Standard Review Plan for Spent Fuel Dry Storage Systems and Facilities

Standard Review Plan for Spent Fuel Dry Storage Systems and Facilities; Request for Comment on Draft NUREG

Document: NRC-2017-0211-DRAFT-0005

FIGURE A.2

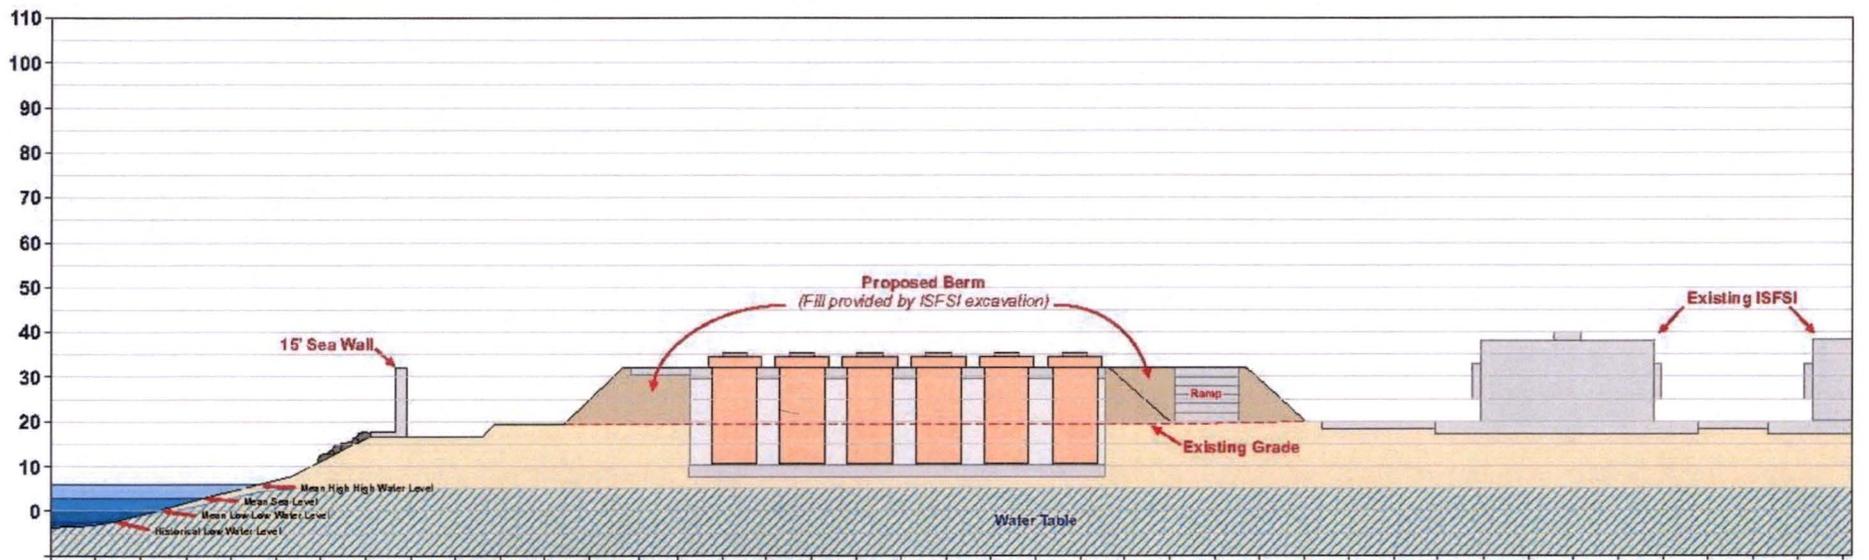
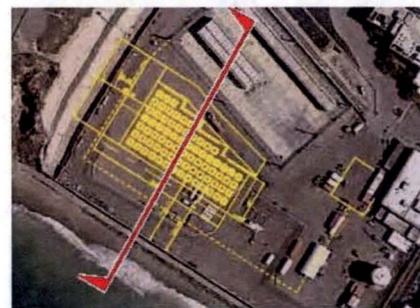
Surely they will not allow a storage system that is designed to be built 'below ground' to be built PARTIALLY below ground with less than half the height of the cans buried because a fully buried system would hit the water table.
